Subregional RTEP Committee – Mid-Atlantic FirstEnergy Supplemental Projects

May 15th 2025

Change to the Existing Projects

Penelec Transmission Zone M-3 Process Warren – Falconer 115 kV Line: New Customer

Penelec Transmission Zone M-3 Process Warren – Falconer 115 kV Line: New Customer

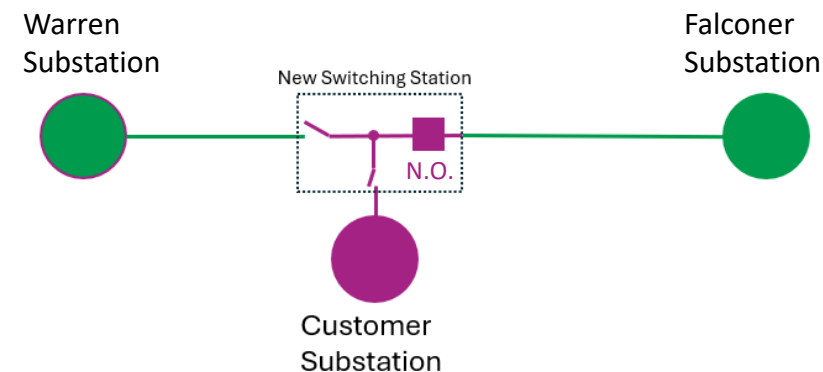
Requested in-service date is ~~12/31/2024~~ **04/28/2028**.

- Tap the Warren – Falconer 115 kV Line, install switches and build approximately 190 ft of transmission line from tap point to customer substation
- Construct new 115 kV switching station near the Warren - Falconer 115 kV Line
- Install two SCADA controlled transmission line disconnect switches with full load break interrupters
- Install one 115 kV circuit breaker (Normally Open)
- Install one 115 kV revenue metering package at customer substation
- Adjust relay settings at Warren Substation
- ~~Operate disconnect switch towards Falconer Substation as normally open~~

Estimated Project Cost: ~~\$1.5M~~ **\$8.45M**

Projected In-Service: ~~04/28/2027~~ **04/28/2028**

Provide 115 kV service from the Warren – Falconer 115 kV Line:
